# PLANNING COMMISSION REGULAR MEETING

### 2. Major Impact Review - 505 Oak Street Planned Development and Major Subdivision

**AGENDA ITEM TITLE:** A. 505 Oak Street Planned Development; and  
B. 505 Oak Street Major Subdivision

RE: 505 Oak Street Major Impact Review and Planned Development Engineering Comments  
JVA Job# 3121.17c

**505 OAK STREET P.U.D.**  
 SALIDA, CO  
**CIVIL ENGINEERING PLANS**  
**SITE PLAN**  
 SITE DIMENSIONS, LANDSCAPE

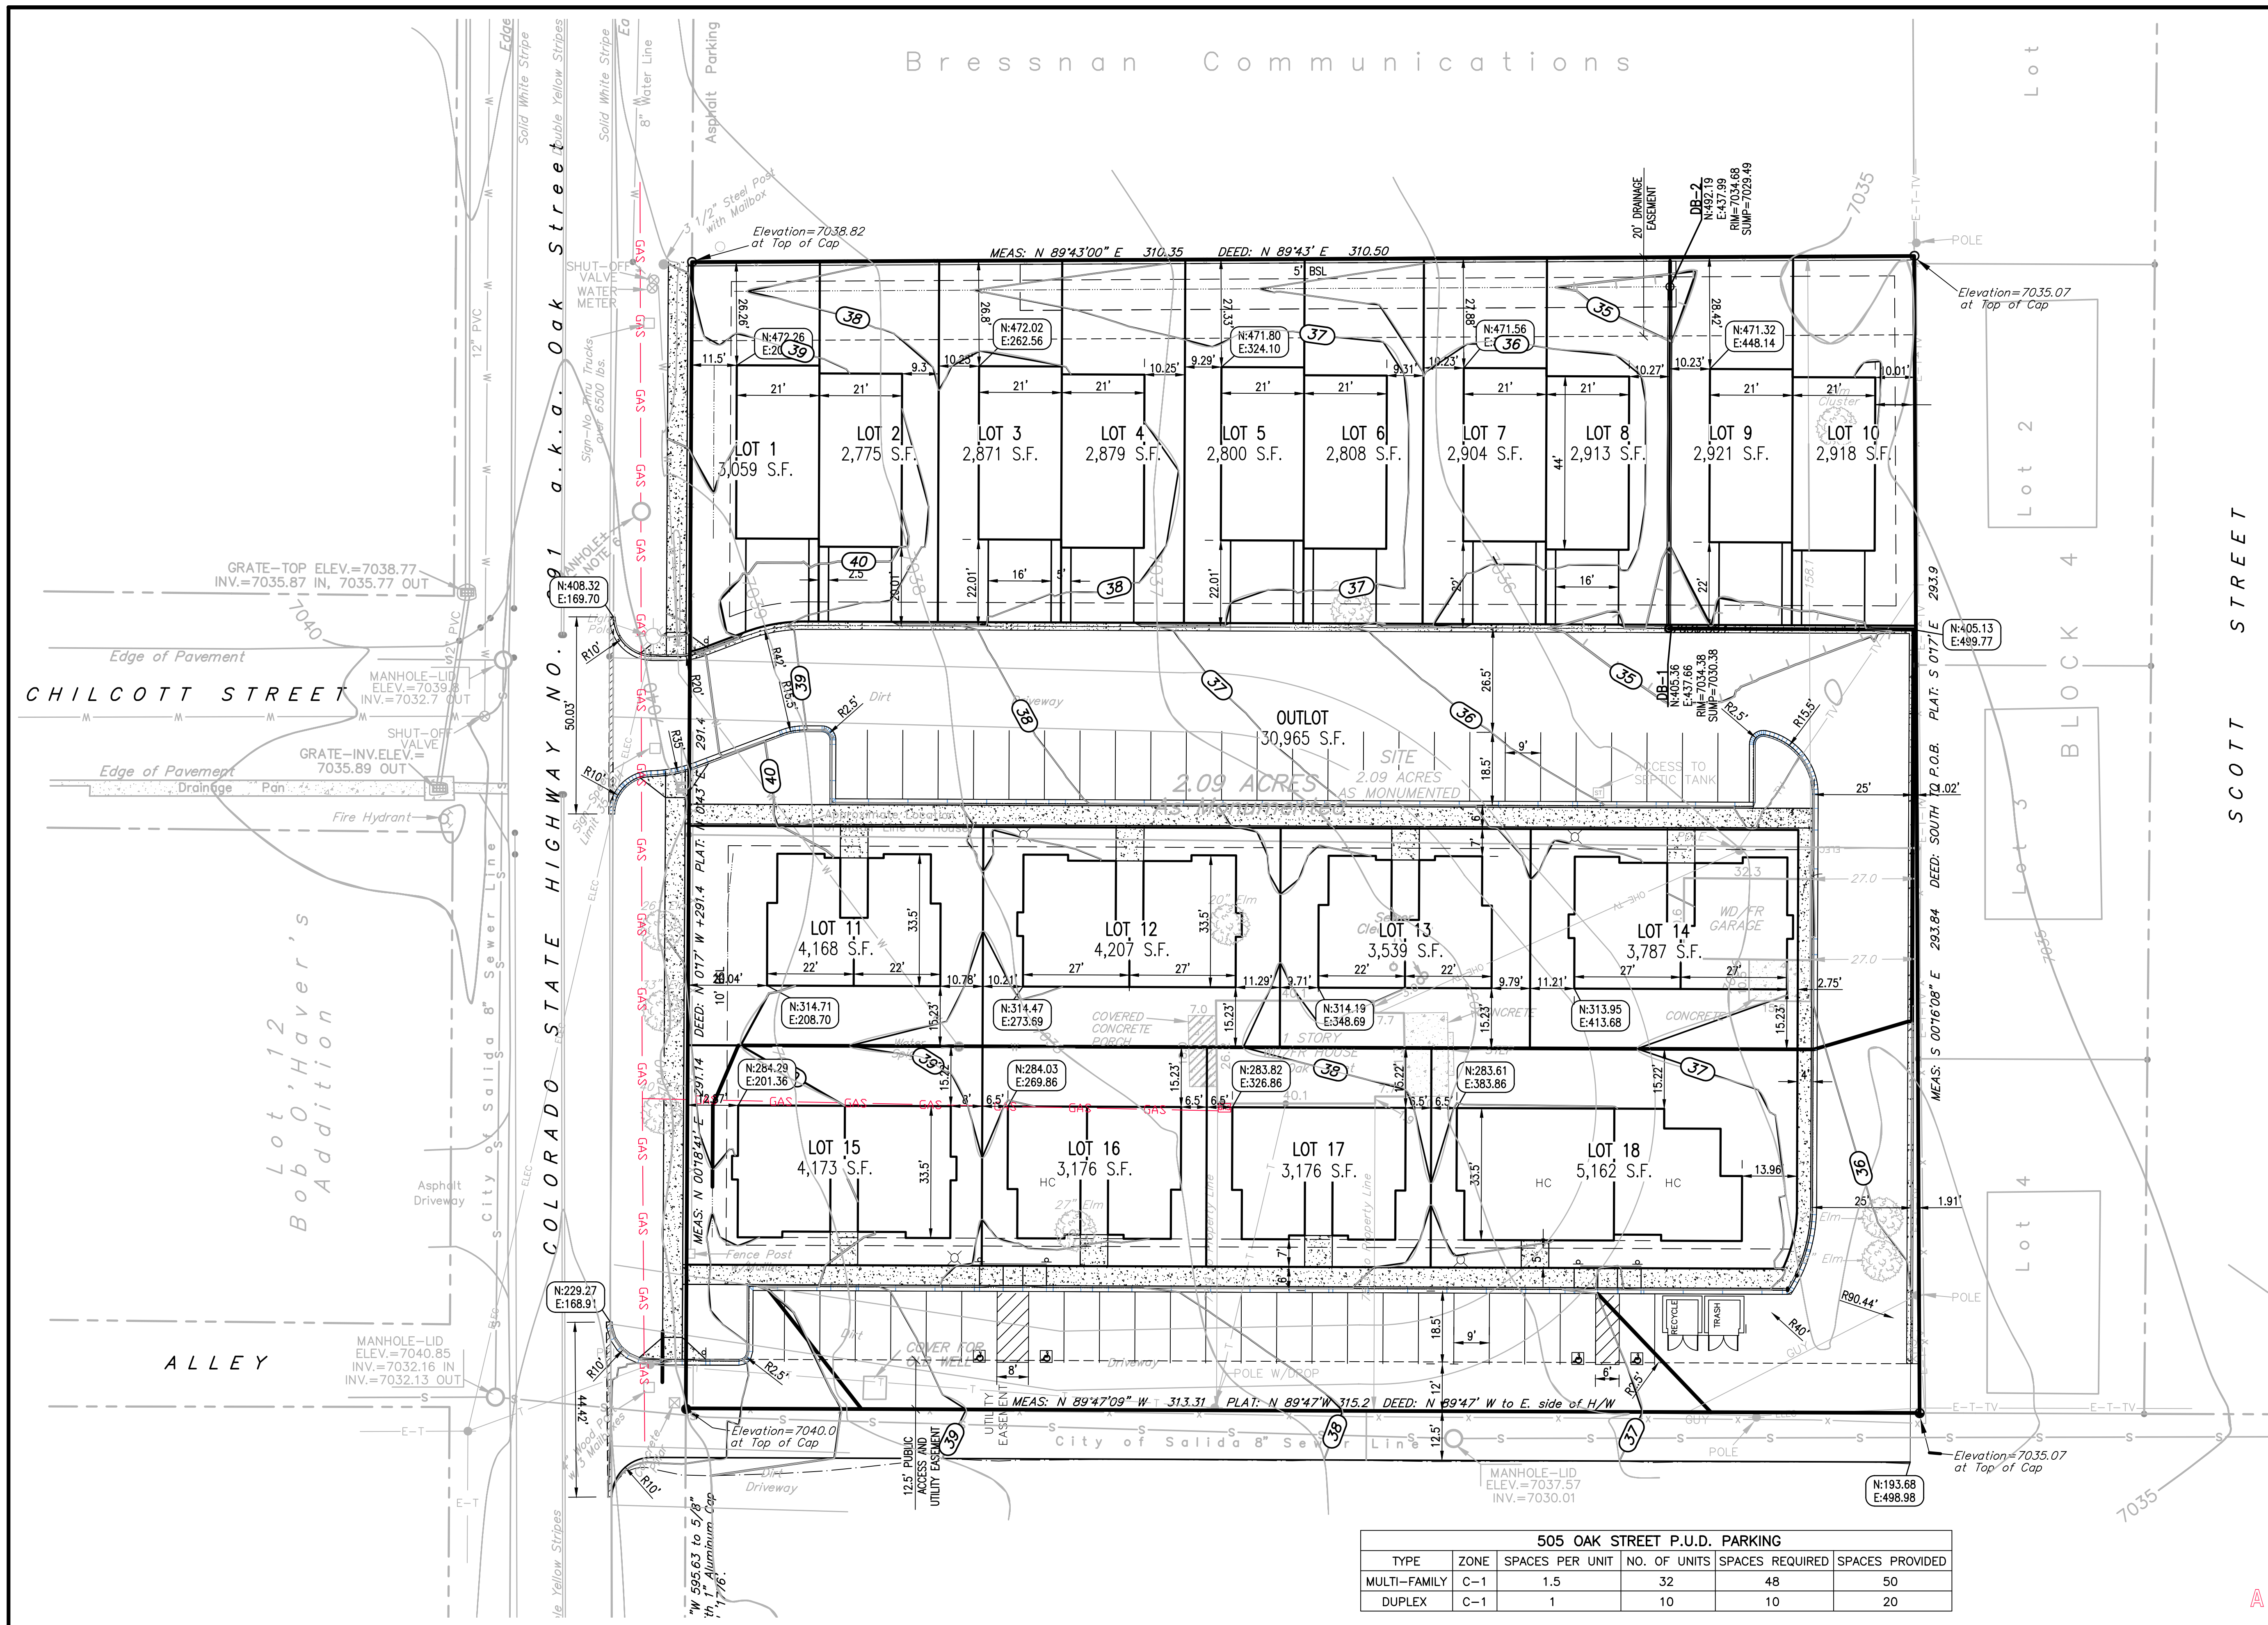
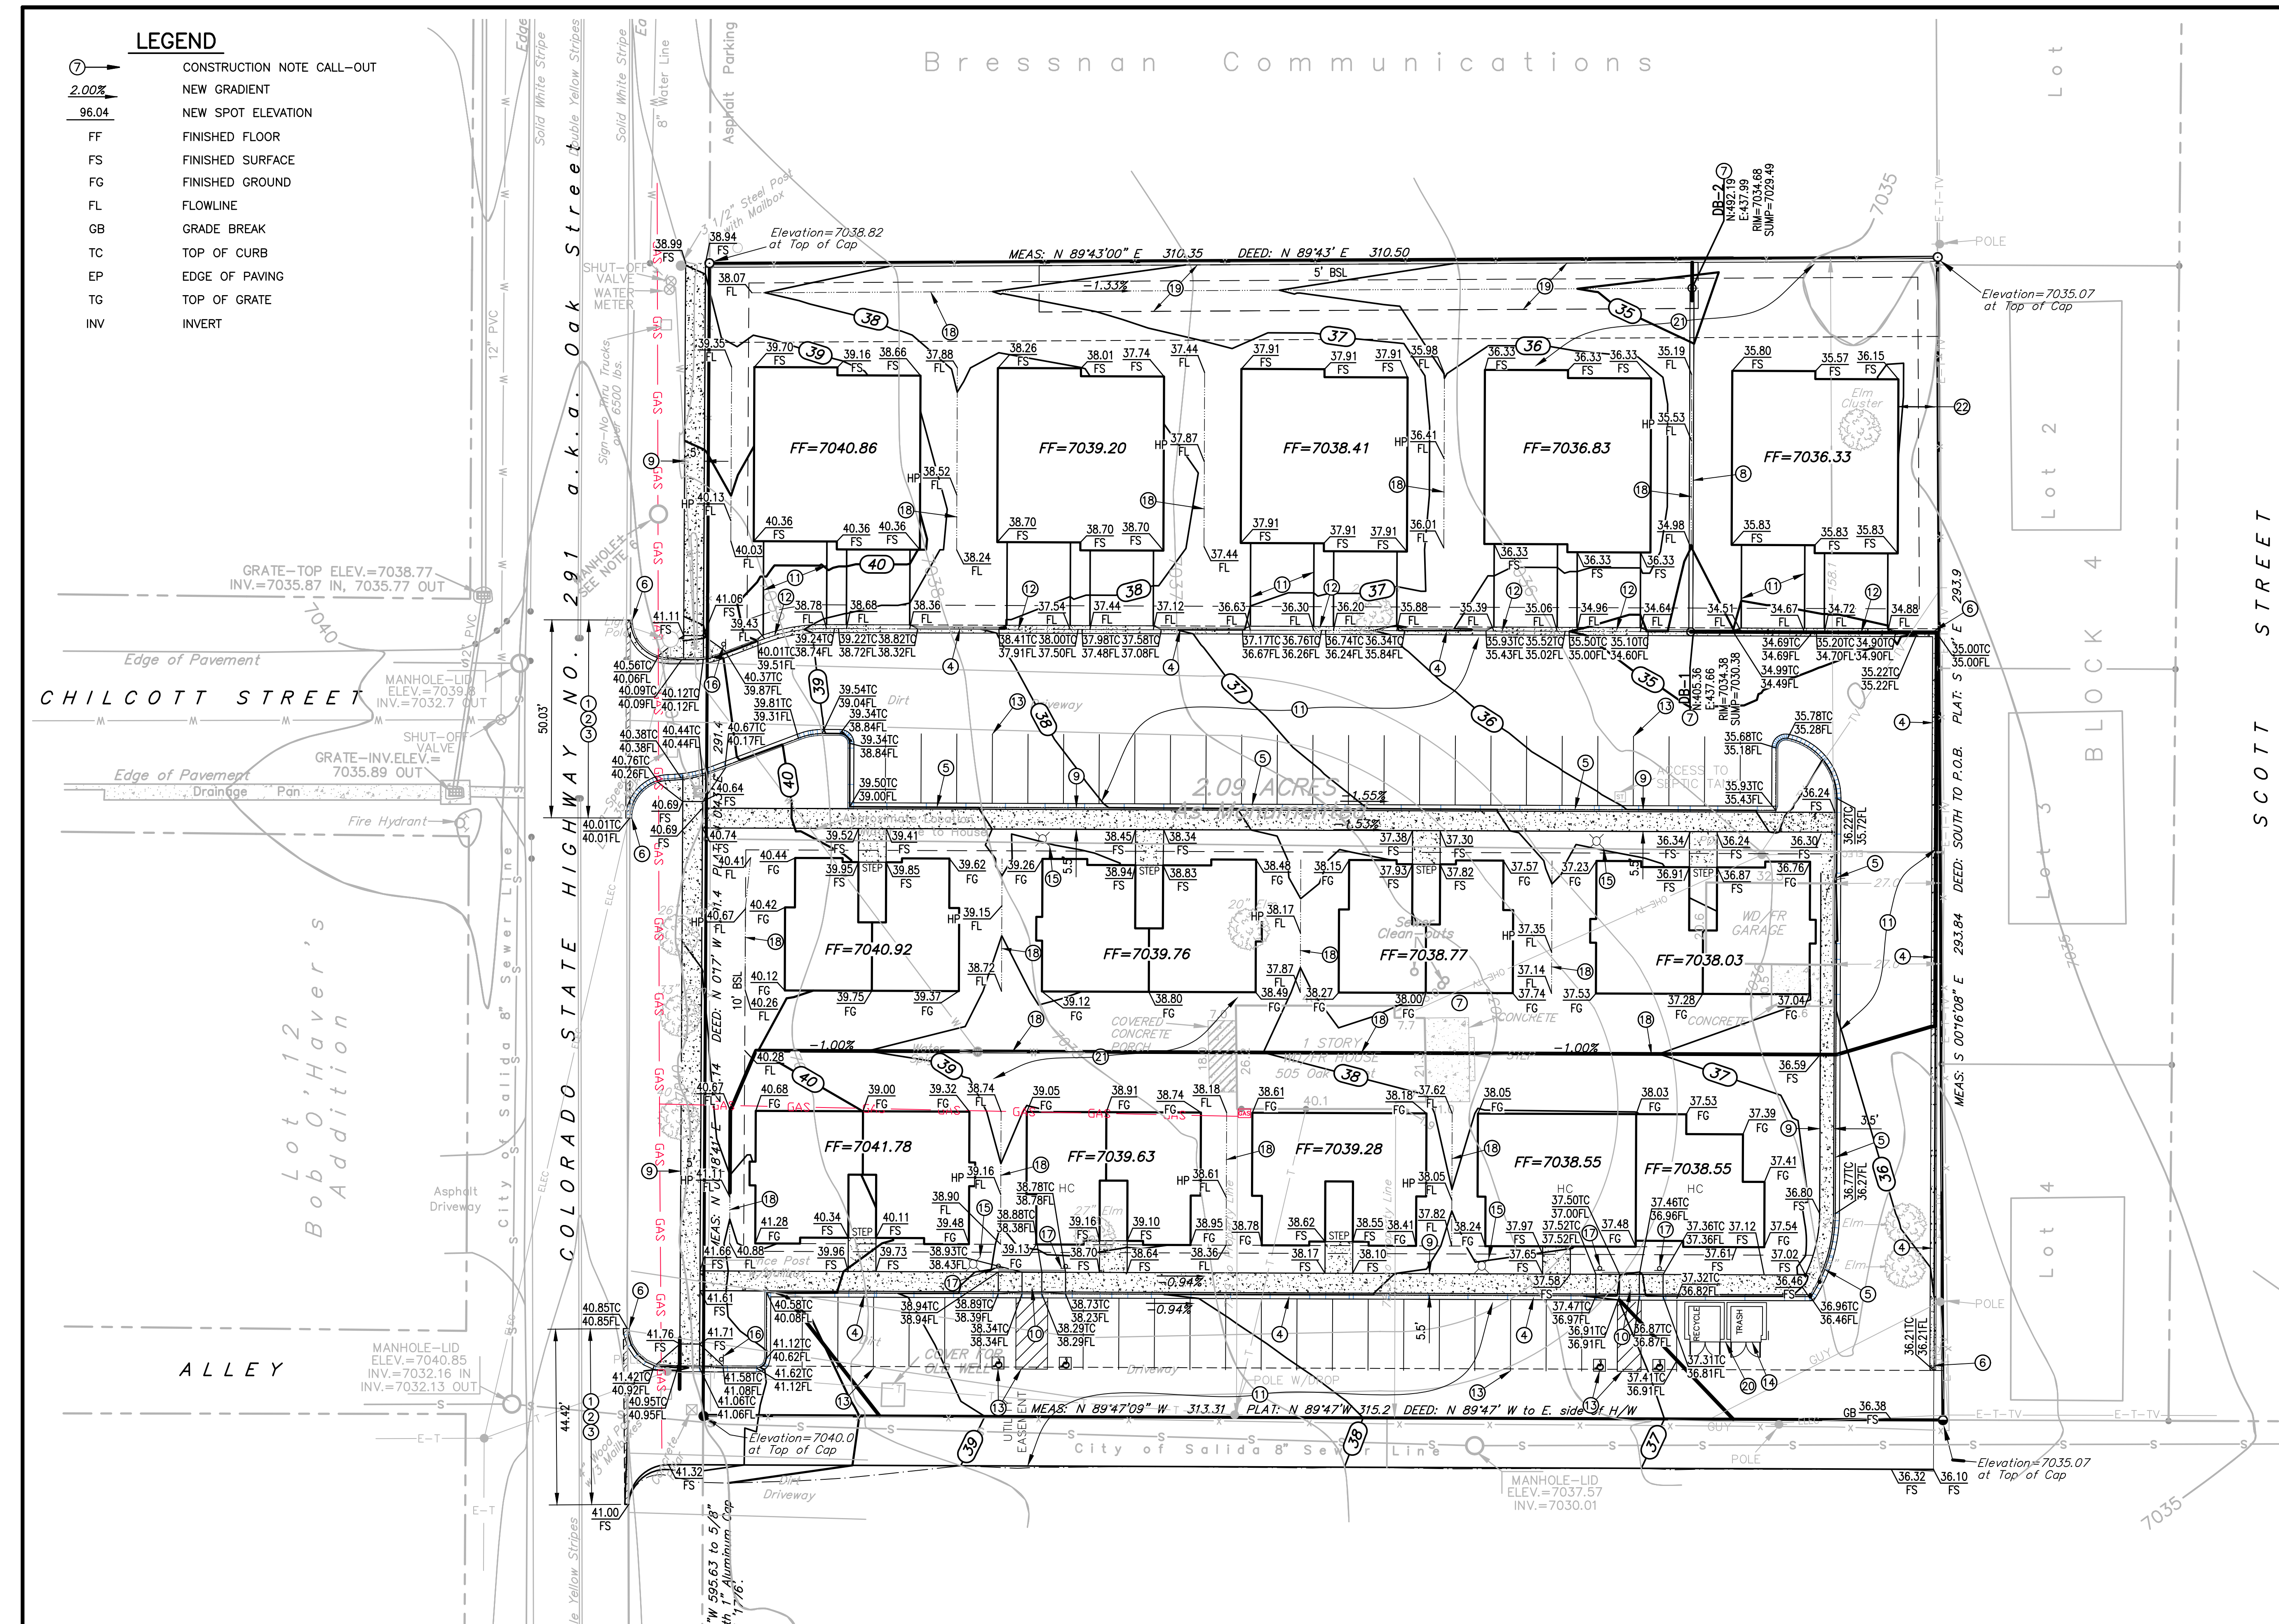
- ii. Per previous comment, the fire hydrant located at STA 3+72 shall be shifted south to be at the water main cap near STA 4+18. Coordinate final location with public works and fire department

- v. The 505 Oak Street PUD Written Description states that a fire hydrant is to be provided at the northeast corner of the site how does not appear on the Utility Plan. Provide as required

- vi. Clarify note 49 on sheet number 4 in regards to dual meter. Plans show single meter
- c. Provide information for fee in lieu ROW improvement quantities and pricing

- d. Emergency Services: Provide confirmation from fire department emergency vehicular turning movements through site, and fire protection improvements

SHEET NO. **3**  
 OF 15 SHEETS.  
 PROJECT NO. 22007

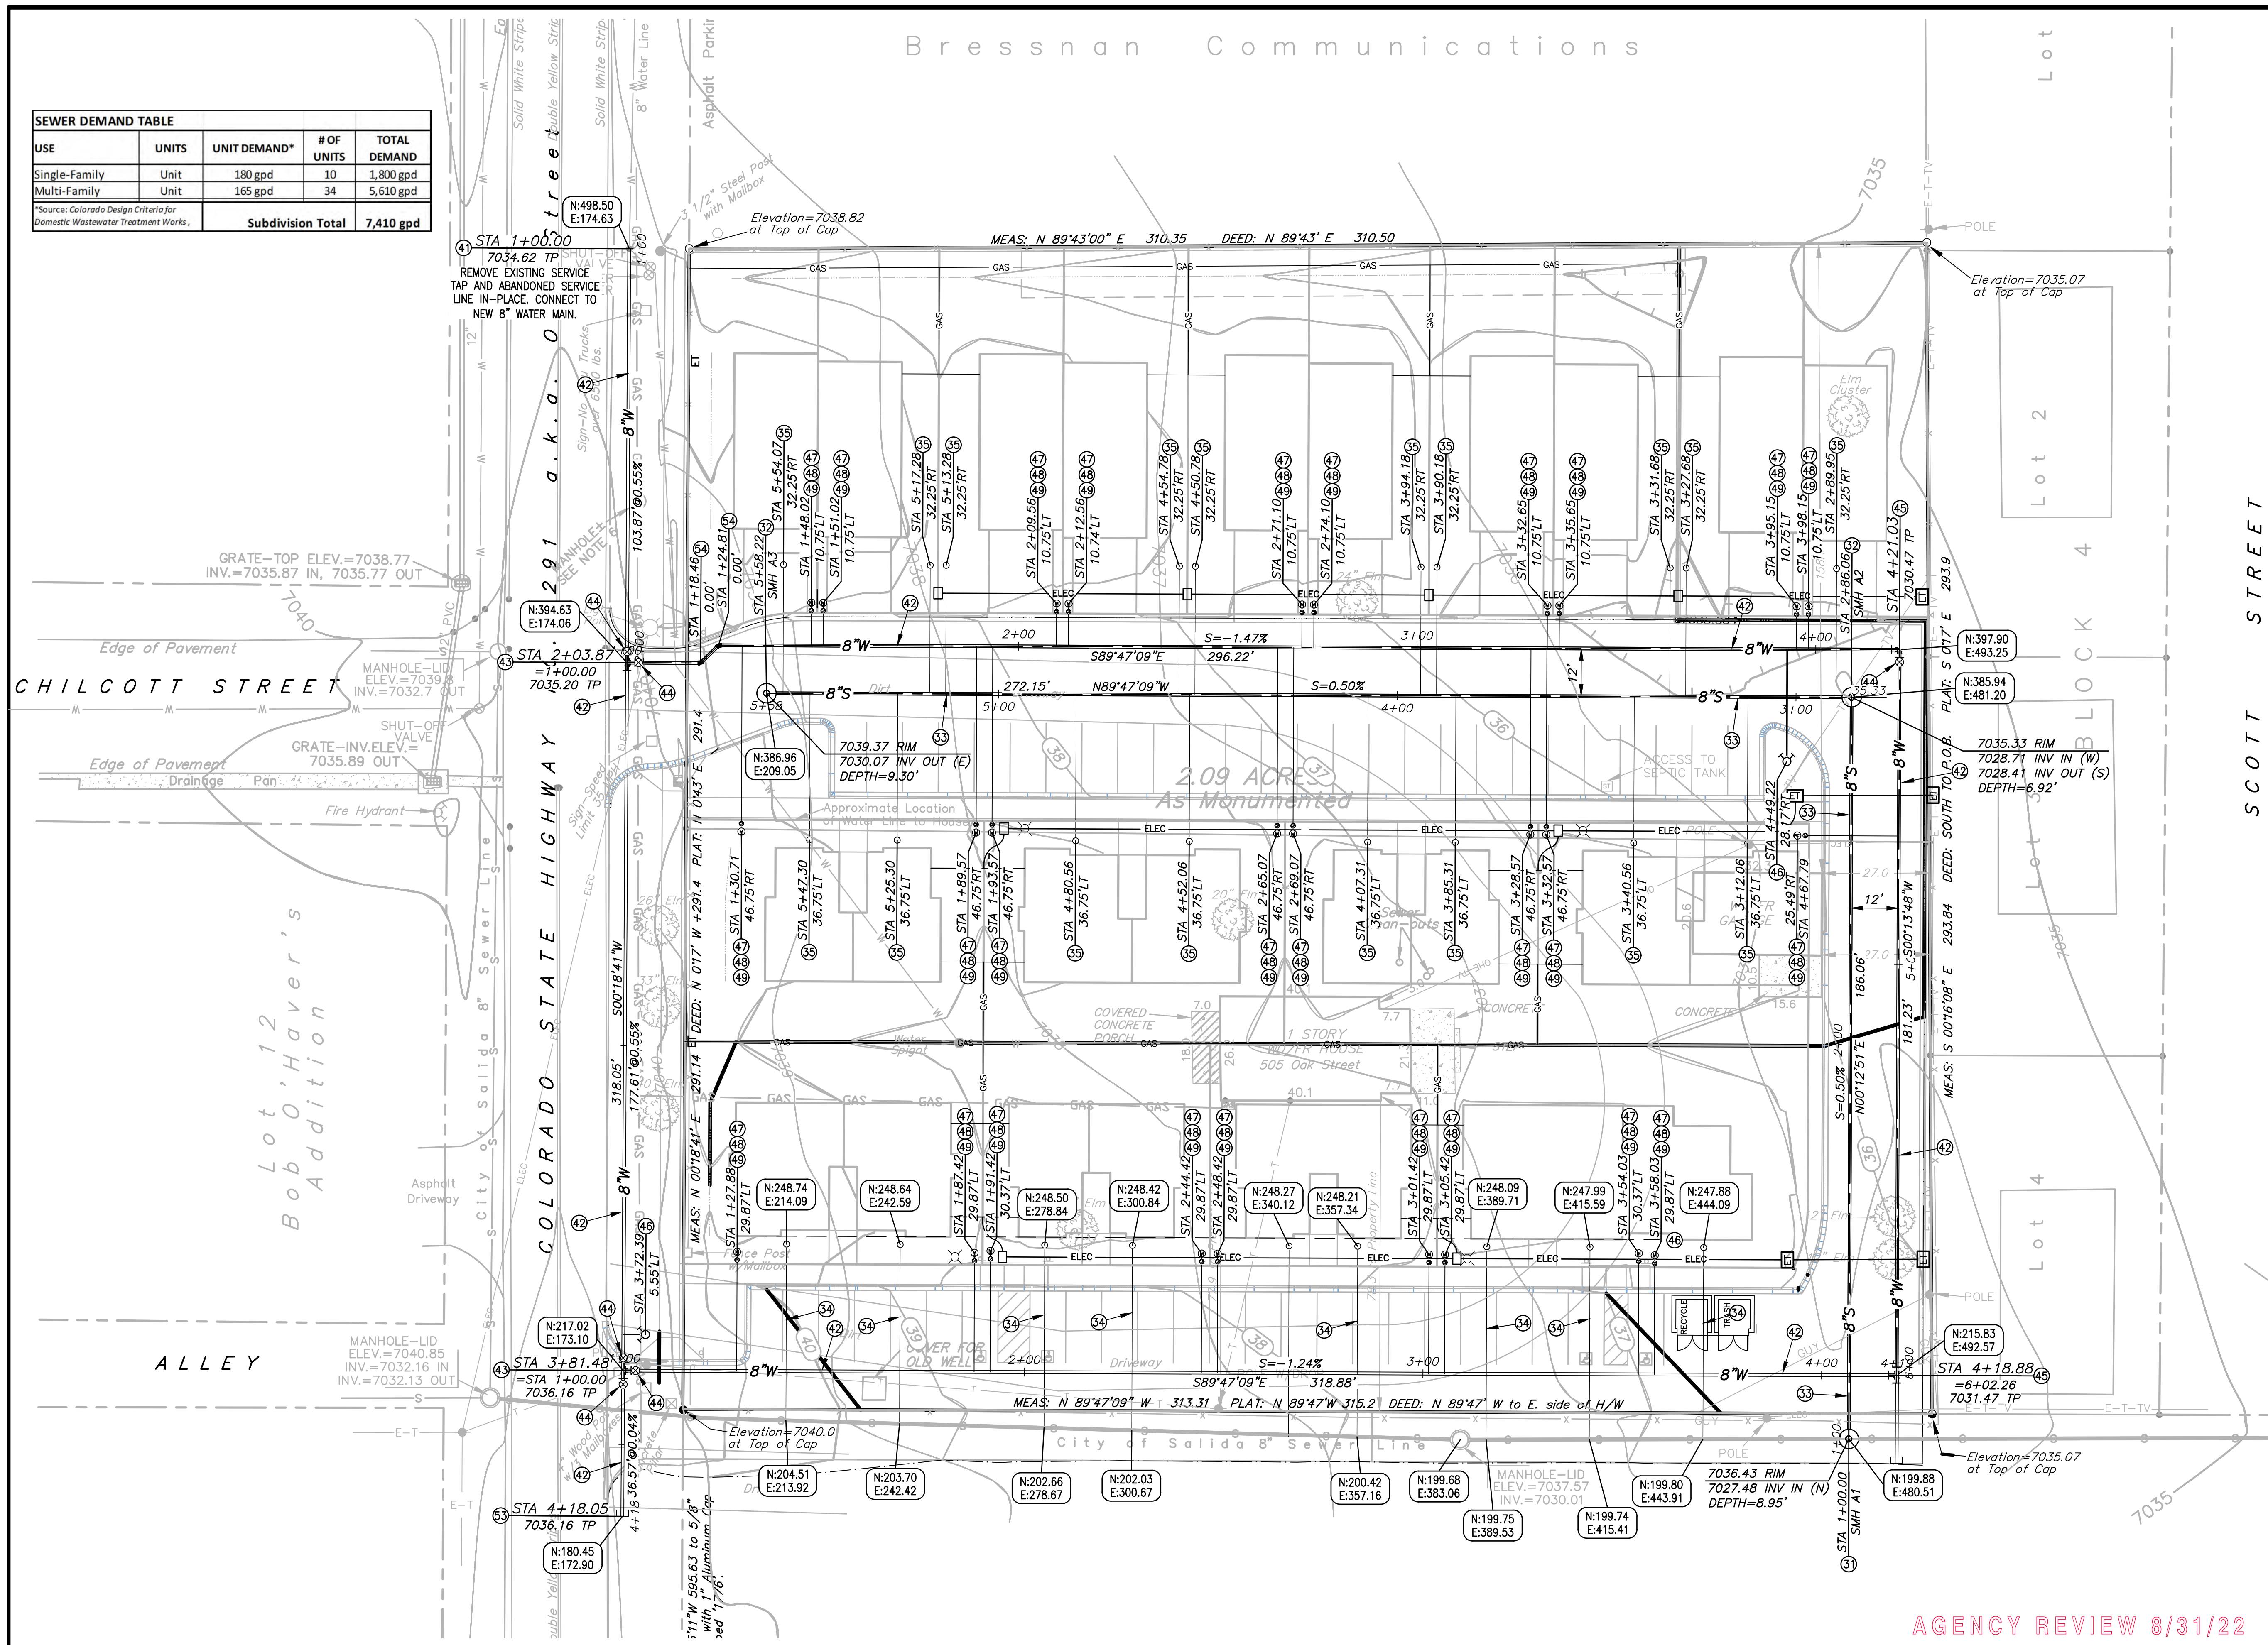
- iii. Private utilities such as gas, electricity and communications will be required to be in a utility easement or outlot
  - b. Utilities:
    - i. Provide plan and profiles, with crossings, of public water and sewer sewer mains

- iii. Coordinate with Public Works to ensure that water main valves within Highway 291 are not in conflict with future street improvements
    - iv. Provide landscape irrigation water meter with supporting calculations confirming water meter size or confirm that irrigation will be provided separately for each lot.
